Author Details	
Name	Dr Andrew Boswell
Position	Independent Scientist & Consultant
NZT Registration	20029943
Organisation	Climate Emergency Policy and Planning (CEPP)
Examination Principle Issues	<ul style="list-style-type: none"> • Full lifecycle Greenhouse Gas (GHG) emissions • Cumulative assessment of GHG emissions • Air Quality • Scope of Development and Environmental Impact Assessment

POST EXAMINATION CONSULTATION – 6th SEPT 2023

Figure 2: CCC Progress Report 2023, Fig 4b reproduced

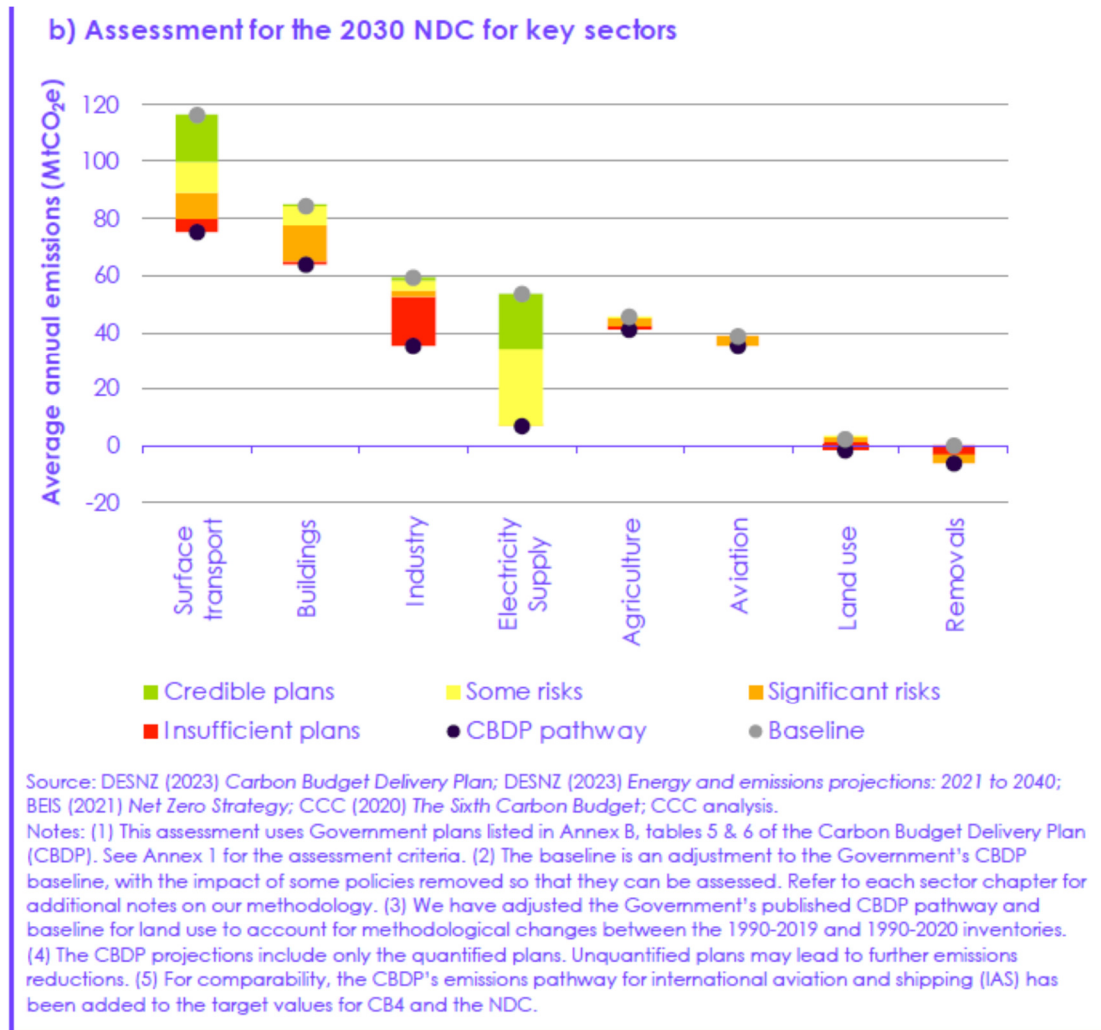
44 Figure 4b on page 24 of CCC_2023_PROG, reproduced below, shows that the electricity supply sector has large emission reductions²³ to make for the 2030 NDC. Electricity supply is required to reduce from a baseline of 53.8 MtCO₂e/yr to 6.7 MtCO₂e/yr (the “CBDP pathway”) in 2030. The CCC assess credible plans only existing for 41% of this (19.3 MtCO₂e/yr – green on the Figure). There are risks for 27.7 MtCO₂e/yr (yellow on the Figure) of electricity supply emission reductions for the NDC.

45 Note that the Fuel Supply sector is not illustrated on Figure 4b: however, the data is provided in the accompanying spreadsheet²⁴. The Fuel Supply sector is required to reduce from a baseline of 23.9 MtCO₂e/yr to 20.0 MtCO₂e/yr (the “CBDP pathway”) in 2030. The CCC assess credible plans only existing for 25.5% of this (1 MtCO₂e/yr – equivalent to green on the Figure). There are risks for the remaining 2.9 MtCO₂e/yr of fuel supply emission reductions for the NDC.

Figure 3: CCC Progress Report 2023, Fig 7.7 reproduced

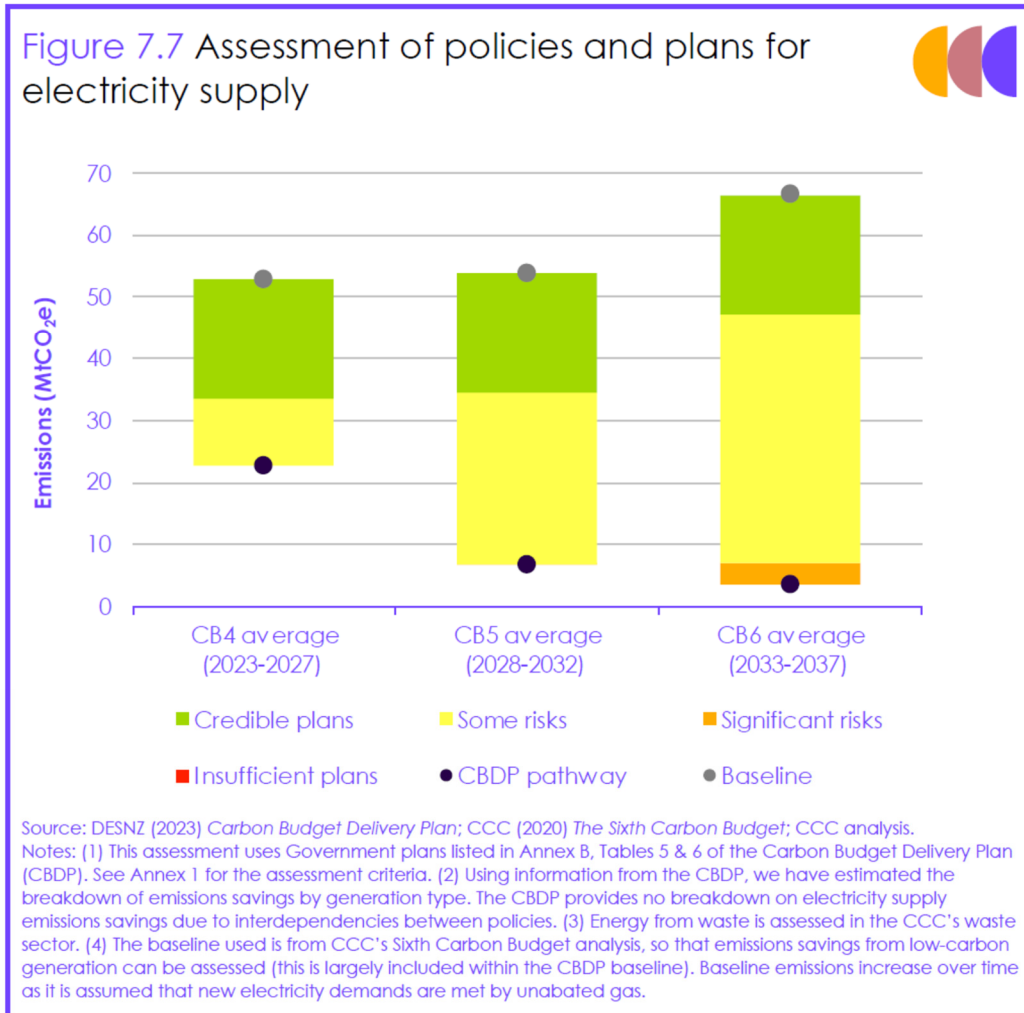
46 Figure 7.7 on page 211 of CCC_2023_PROG, reproduced below, shows the assessment of policies and plans for electricity supply across the 4th, 5th and 6th carbon budgets.

47 For the 6CB, electricity supply is required to reduce²⁵ from a baseline of 66.5 MtCO₂e/yr to 3.5 MtCO₂e/yr (“Government Pathway”). The CCC assess credible plans only existing for

30% of this (19.3 MtCO₂e/yr – green on the Figure). A remaining 43.8 MtCO₂e/yr of electricity supply emissions reductions require to be fully secured in the 6CB.

Figure 4: CCC Progress Report 2023, Fig 8.7 reproduced

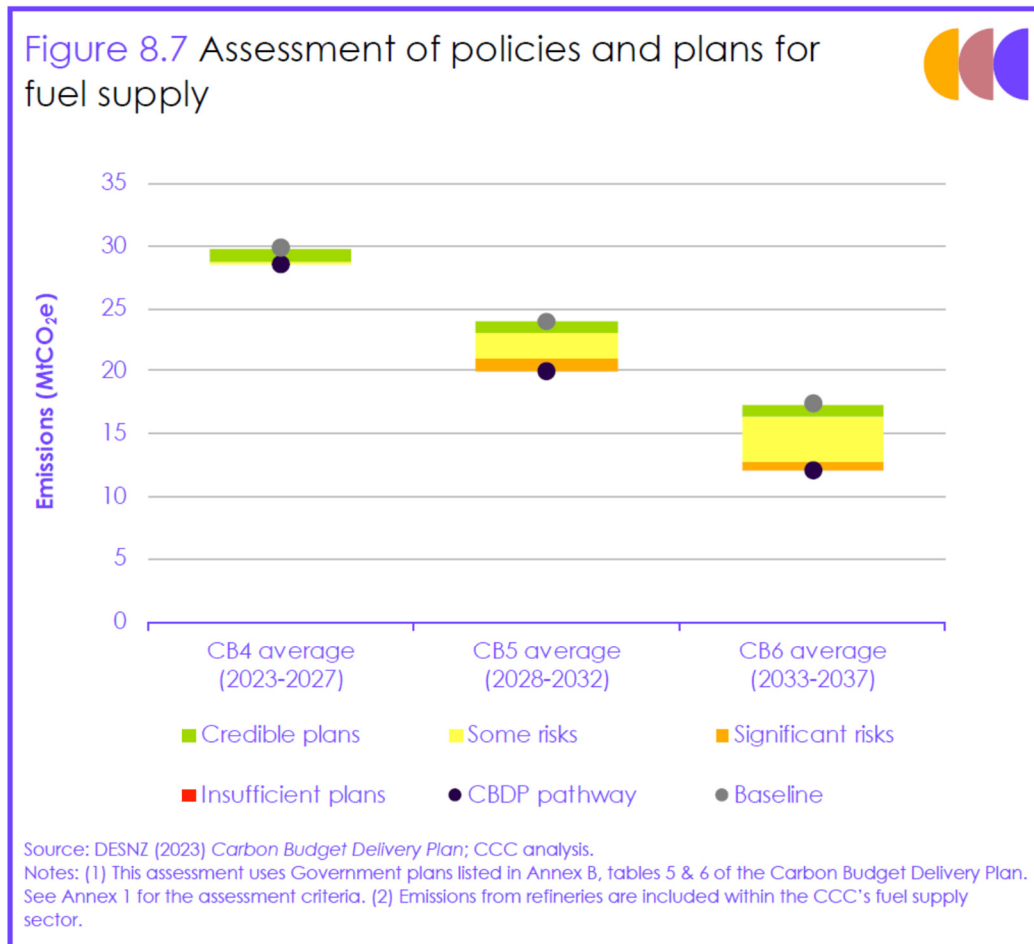
48 Figure 8.7 on page 230 of CCC_2023_PROG, reproduced below, shows the assessment of policies and plans for fuel supply across the 4th, 5th and 6th carbon budgets.

49 For the 6CB, fuel supply is required to reduce²⁶ from a baseline of 17.3 MtCO₂e/yr to 12.0 MtCO₂e/yr (“Government Pathway”). The CCC assess credible plans only existing for 17% of this (0.9 MtCO₂e/yr – green on the Figure). A remaining 4.4 MtCO₂e/yr of fuel supply emissions reductions require to be fully secured in the 6CB.

Figure 5: Carbon footprint of UK natural gas imports (reproduced from NSTA)

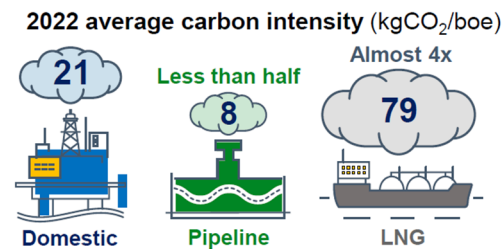
80 Factor (1) was recently highlighted by a methane (natural gas) carbon footprint analysis by the North Sea Transition Authority (NSTA) which showed gas extracted from the United Kingdom Continental Shelf (UKCS) has an average emission intensity of 21 kgCO₂e/boe; whereas imported LNG has a significantly higher average intensity of 79 kgCO₂e/boe (ie: on average 4 time greater). The NSTA fact sheet is reproduced in Appendix A with a diagram illustrating the point above, reproduced below.

81 Consider with Factor (2), the fuel source location, the NSTA analysis shows that in 2022 the UK used 38% of methane from UK sources, and 14% from the US. However, when the CO₂e emissions were estimated from these sources, the US LNG supplies generated 35% of upstream emissions compared to 24% for the UK supply (see “2022 UK gas supply and emissions” in Appendix A). In other words, the upstream emissions were dominated by high methane leakage in supplies from a relatively small total of the gas used in the UK.
